The Commission has issued the enclosed Amendment No. 23 to Facility Operating License No. NPF-30 for the Callaway Plant, Unit 1. This amendment is in response to your application dated December 19, 1986.

The amendment revises Technical Specification Figure 3.9-1 with correct curves for Westinghouse optimized fuel (OFA) and standard fuel (SFA). Figure 3.9-1 now also incorporates a curve for Westinghouse Vantage Fuel (V5) which overlays the OFA curve. TS sections 5.3.1 and 5.6.1.1 are also revised to reflect a maximum enrichment of 4.25 w/o U-235 for fuel storage.

Amendment No. 23  
License No. NPF-30

SAFETY EVALUATION BY THE OFFICE OF NUCLEAR REACTOR REGULATION  
RELATED TO AMENDMENT NO. 23 TO FACILITY OPERATING LICENSE NO. NPF-30

FUEL ASSEMBLY INITIAL ENRICHMENT, W/O U-235  
 FIGURE 3.9-1  
 MINIMUM REQUIRED FUEL ASSEMBLY BURNUP AS A FUNCTION  
 OF INITIAL ENRICHMENT TO PERMIT STORAGE IN REGION 2

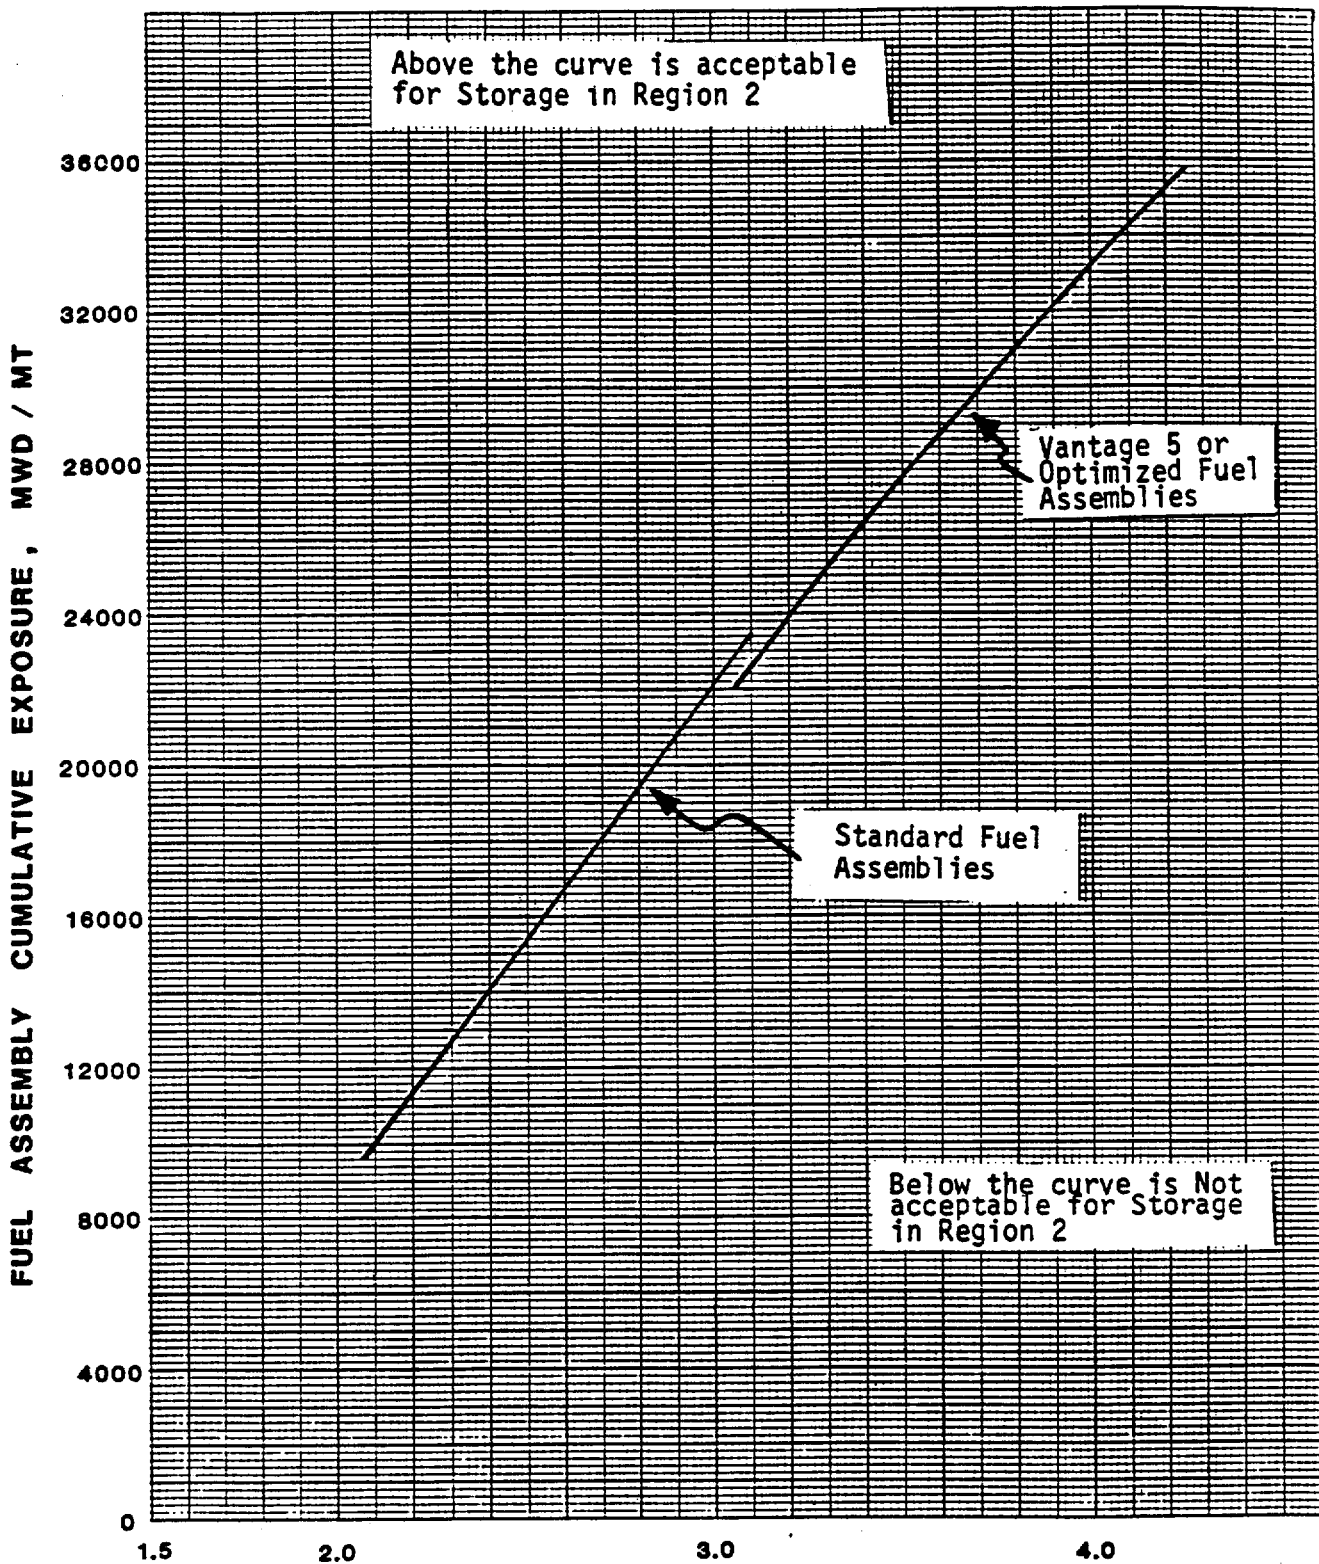
In the course of performing supplemental calculations to verify criticality limits for V5 fuel storage, discrepancies were identified between the current work and that provided in 1985. The discrepancies were reviewed and the source of errors was identified. The errors rendered incorrect both the SFA and OFA curves currently presented in Figure 3.9-1 of the Callaway TS.

The discrepancy in the OFA curve was traced to the use of an incorrect multiplier on the fission product absorption cross section. Further investigation showed that the original (FSAR) analysis had been correctly done. The error produces non-conservative values for the burnup required for storage in Region 2 of the spent fuel pool. The error was of the order of 2000 MWd/MT in burnup for the OFA fuel.

The discrepancy in the SFA curve was traced to an incorrect transcription of data from the original SFA calculated curves. This transcription error resulted in a similar non-conservative error for the SFA as the OFA.

The licensee, in the December 19, 1986 submittal, presented revised curves for the standard and OFA fuel assemblies for enrichments up to 4.20 weight percent U-235. Also presented were analyses to support the storage of V5 and OFA fuel having enrichments up to 4.25 weight percent U-235. The analyses show that the same curve of required burnup as a function of initial enrichment may be used for both the V5 and OFA assemblies.

Analyses were performed for Region 1 to confirm that storage of fuel having an enrichment up to 4.25 weight percent U-235 results in a k-effective value, including uncertainties, of less than our acceptance criterion of 0.95 for this quantity. The revised curves of required burnup as a function of initial enrichment were extended to an enrichment of 4.25 weight percent U-235 using the previously approved methods. Particular attention was paid to quality assurance during the analysis. We conclude that the revised curves are acceptable.

The changes to the TS include replacement of Figure 3.9-1 with the revised curve and changing the maximum enrichment value in Specifications 5.3.1 and 5.6.1.1 to 4.25 weight percent U-235. These revisions are consistent with the safety analyses provided and are, therefore, acceptable.
